NOTICE OF PUBLIC HEARING Minor Variance

APPLICATION NO.: HM/A-22:33

SUBJECT PROPERTY: Municipal address 105 MacNab St. S., Hamilton

Zoning Comments Response

1 SITE PLAN
A1.0 1/8"=1'-0"

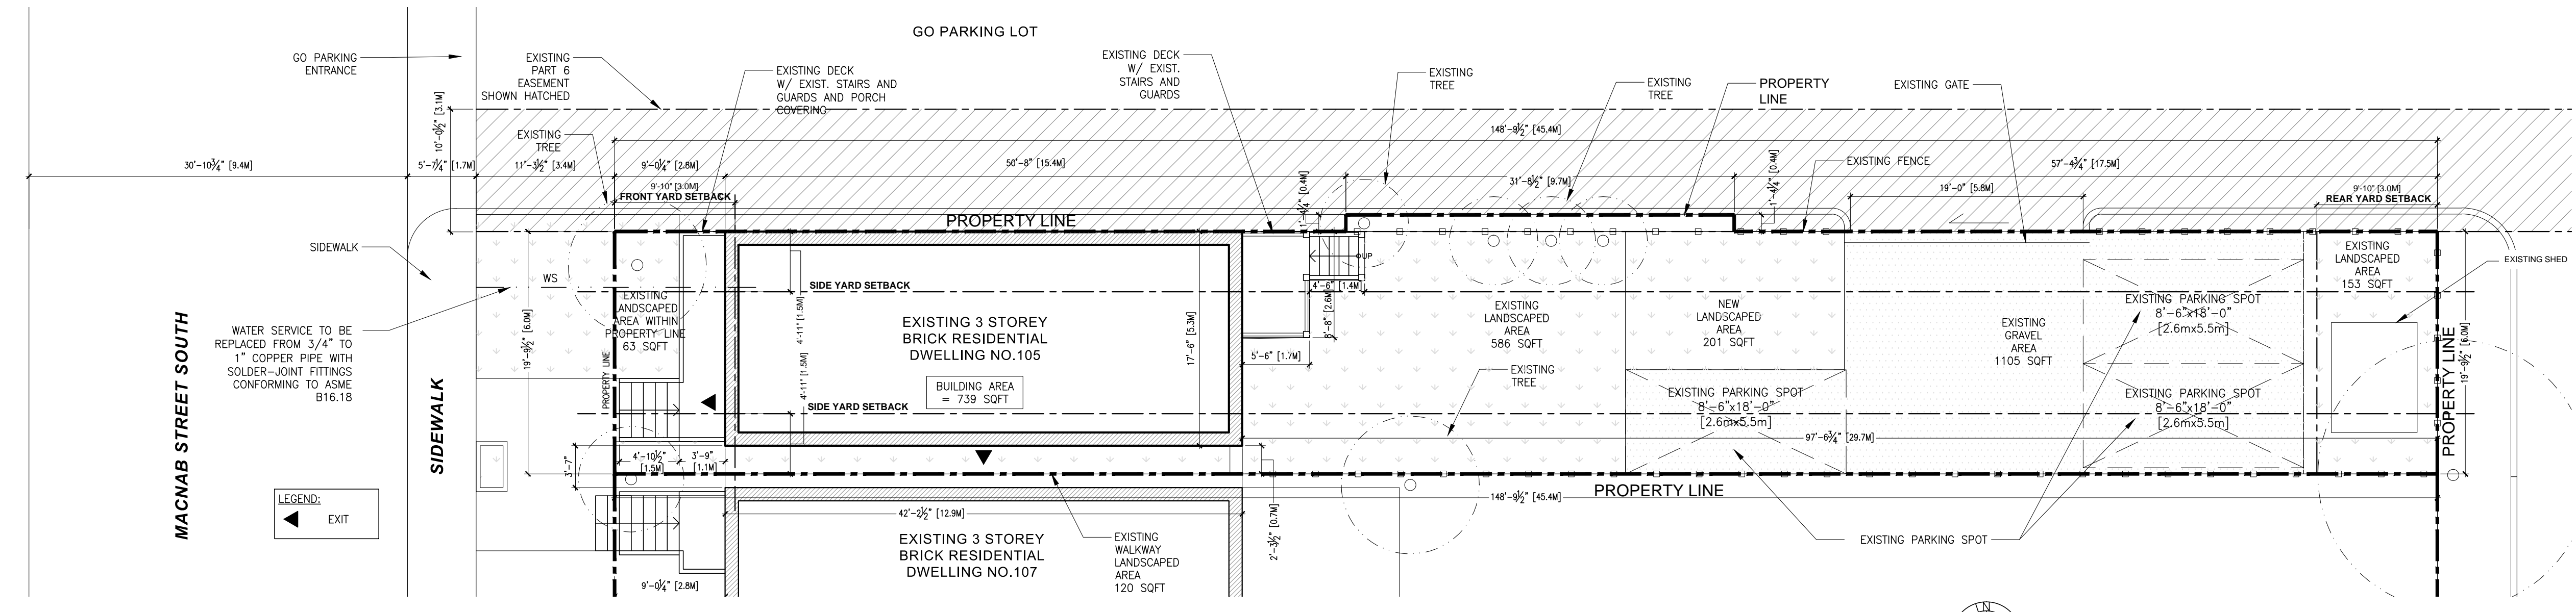
Z3. A Landscaped Area is required as per Section 11C(5) within Hamilton Zoning By-law 6593. There is no landscaped area provided. Therefore, a successful application to the Committee of Adjustment is required. For further information, please send an email to cofa@hamilton.ca

Response: We are seeking relief for this zoning requirement. Please refer to drawings 1/A1.0 and 4/A1.0 on document MV_105 MacNab St. S_A0.0 Site Plan.pdf indicating the existing and new landscape area proposed. The minimum landscape area required is 40%. The Landscape area proposed (Existing + New) is 35%. The remaining exterior area within the lot is dedicated to porous gravelled area for Parking Spots as indicated on the drawings. To increase the landscaped area would mean to reduce the parking required for the building.
